**SUBJECT: PALISADES NUCLEAR PLANT - NRC SPECIAL INSPECTION TEAM (SIT)
REPORT 05000255/2012012**

Report No.: 05000255/2012012

Facility: Palisades Nuclear Plant

Palisades Rack and Pinion CRDM

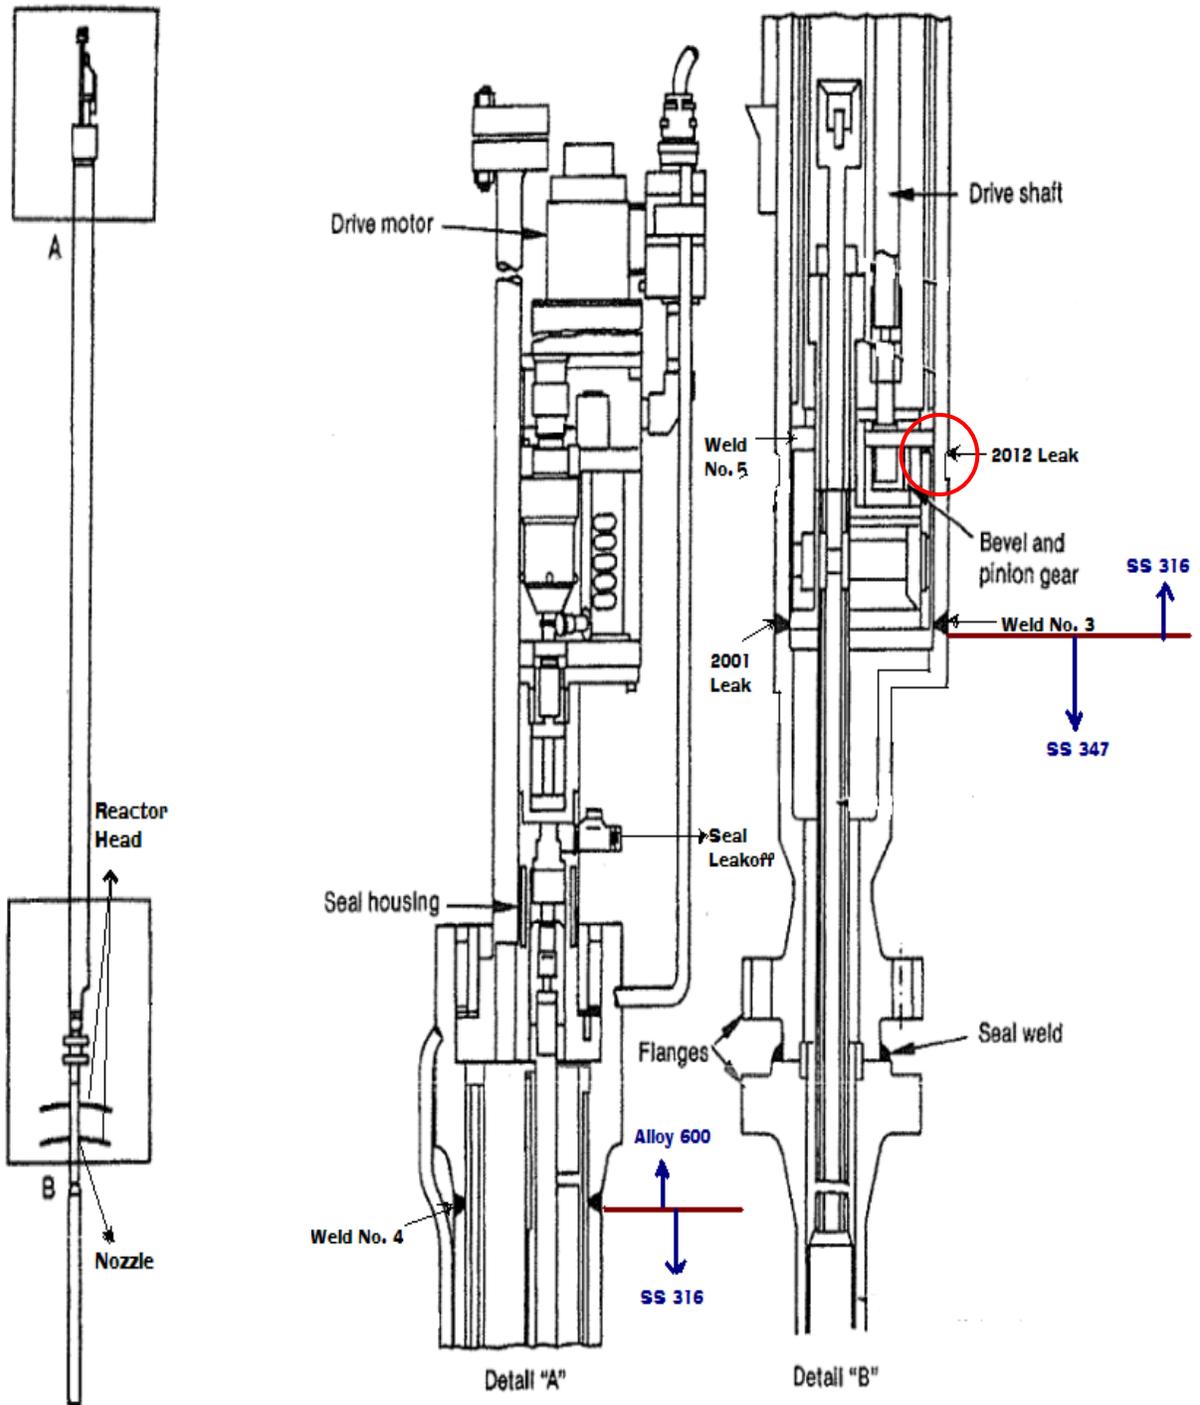
The leak was present in the lower witness band of the Type 316L stainless steel pipe section of the upper housing of CRDM-24 located above Weld No.3 (see attachment 4). Weld No.3 was a butt weld (structural weld) that joined the pipe section and the lower flange assembly of the upper housing assembly. The through-wall leak location was at the upper radius of the witness band opposite the lower taper of the internal weld build up area (non-structural weld No.5) and was axially oriented (see attachment 5). A witness band is a precisely machined area on the exterior of the pipe section used during the fabrication process as a reference for critical dimensions. A laboratory evaluation determined that the cracking in the housing of CRDM-24 was transgranular stress corrosion cracking (TGSCC) initiating from a flaw location on the inner wall, propagating outward to the outer wall. Three concurrent conditions are necessary for TGSCC to occur – namely an accumulation of tensile stresses greater than some minimum, a material that is susceptible to the cracking phenomenon, and an environment that supports cracking. An NRC inspector observed the testing done at this laboratory. In the laboratory, using a dye penetrant test, nine axial cracks were found including the crack that went through-wall. Testing done on eight additional housings (installed on the vessel head), in the same location as the cracks found on CRDM-24, found no cracks.
